Anonymous Referee #2 Received and published: 18 April 2021

The manuscript presents an evaluation of a continental-scale, hyper-resolution model run of a fully coupled hydrologic model. The presented results may serve as a benchmark for model inter-comparisons and guide future ParFlow model improvements. The manuscript is polished and detailed. This reviewer is certainly impressed by its exhaustiveness. Before the manuscript can be recommended for publication in the as-is form, authors are encouraged to address the following concerns:

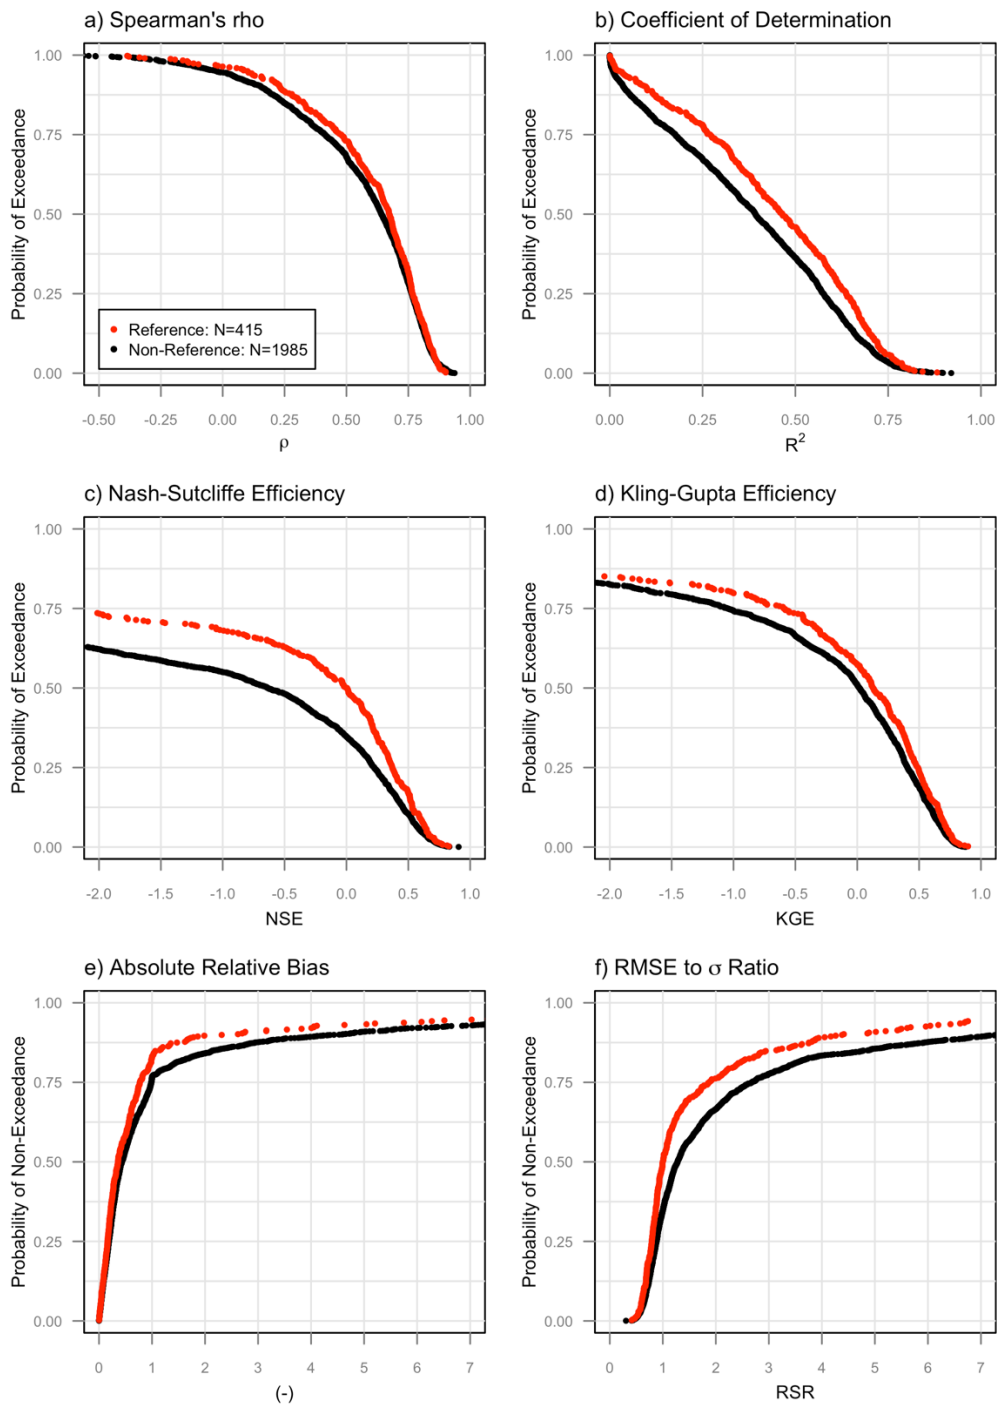
C) While the presented runoff comparisons are quite exhaustive, (future)users of the model and other readers will benefit if exceedance plots for performance metrics are generated. Such a plot will highlight the fraction of observation locations with performance higher than a threshold. These plots may also be generated for different river basins to highlight the relative performance between them. It will help the regional scale modelers. Finally, as it is mentioned that large errors could have been introduced by anthropogenic impacts such as dams etc., separate performance comparisons in Gages-II watersheds could be performed to help address this point. Similar exceedance plots should be generated for other variables as well, as these plots highlight how many grids show performance better than a given threshold, and thus underscore the usefulness of spatially explicit modeling.

Thank you for the suggestion; we have found it to be very helpful, especially in demonstrating the overall performance at the GAGES-II reference gauge locations, versus other sites that are subject to higher anthropogenic influence. Given the current manuscript length and extensive comparisons already made in the form of maps and timeseries, we have decided to include these plots in a supplemental text. We specifically draw this referee’s attention to Figure S1 and S2, shown below, which we believe best address the referee’s point. Figures S1 and S2 show probability of exceedance (or non-exceedance) for various streamflow performance metrics, reference vs non-reference gauges, and major basins. The supplemental text will also include probability of exceedance for other point scale observations and for MODIS products. Since the ESACCI and GRACE remote sensing data were aggregated to the major basin scale for comparison to PFCONUSv1, exceedance plots were not generated for these products as there were too few comparison points (major basins).

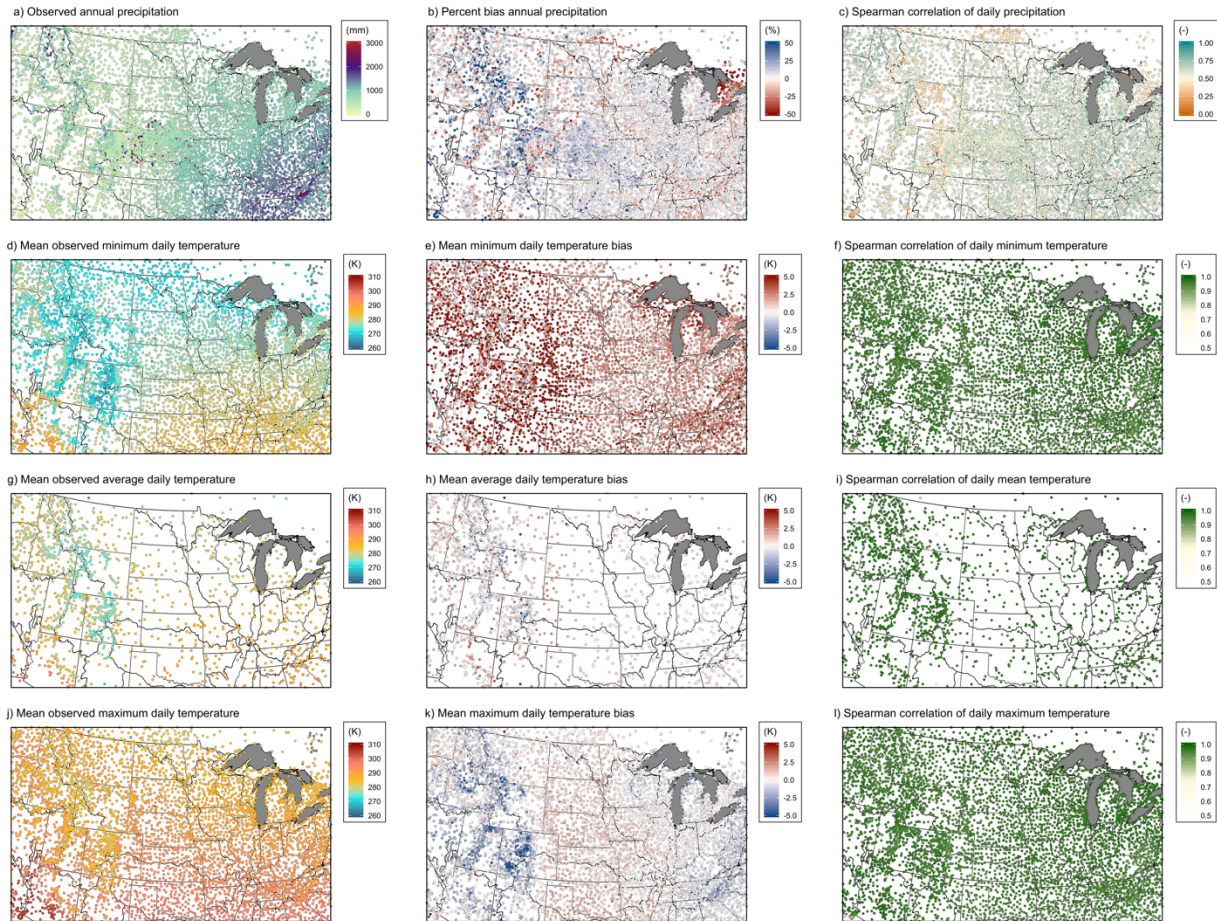
– Fig. 12a: The color palette does not highlight the heterogeneity well. Please consider alternatives.

Thank you for pointing this out. It was a plot formatting mistake – the new Figure 12 shows the correct color scale with subplot (a) adjusted to mirror sizing and scale of other subplots. This is shown below.
